# City of Detroit City Engineering Division, Department of Public Works Survey Bureau

## NOTICE OF PROPOSED CHANGE IN PROPERTY

Petition: x246 ✓

REQUEST TO CONVERT TO EASEMENT  
 THE EAST/WEST, 20 FT. WD. AND A PORTION  
 OF THE NORTH/SOUTH, 16 FT. WD.  
 PUBLIC ALLEY IN THE BLOCK BOUND BY  
 SUSSEX, ORANGELAWN, COYLE  
 AND W. CHICAGO AVE.

CITY OF DETROIT CITY ENGINEERING DEPARTMENT SURVEY BUREAU	
JOB NO.	01-01
DRWG. NO.	X 246

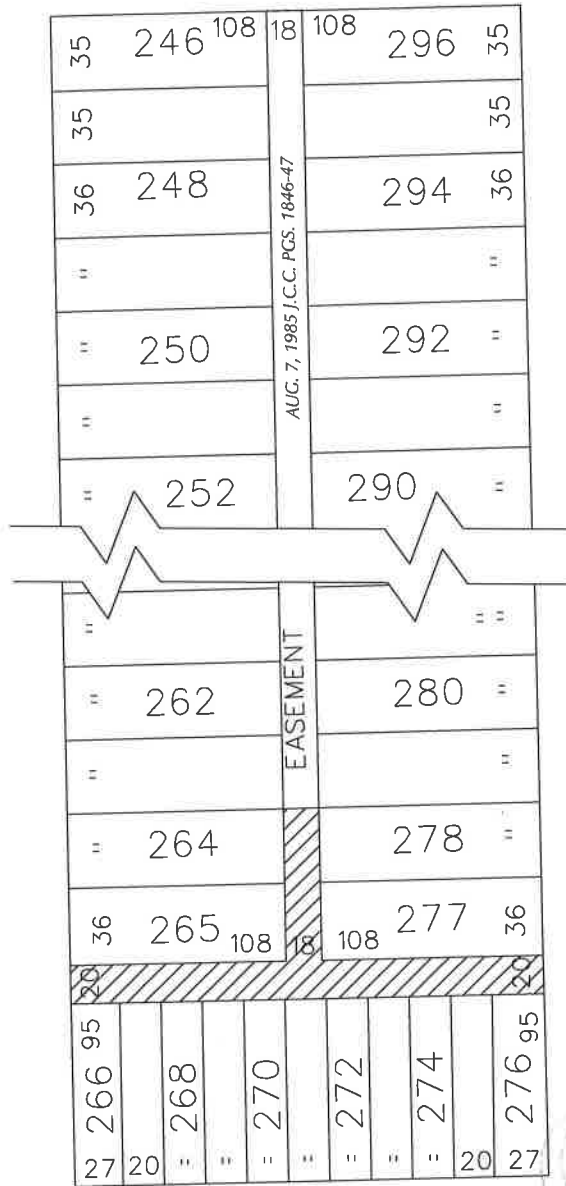
Petitioner has stated that the gate behind the church located at 15112 W. Chicago is never locked, so PLD has 24-hour access to this area. We have no objections to the property change provided the gate is not locked.

The alley is currently part of a parking lot. Petitioner has use of public right-of-way lighting no longer available to the public. Please withhold formal action until this is resolved. Arrangements should be made for petitioner to pay for the light or the light should be removed.

PLD has revised their comments per email forwarded 11/25/14.
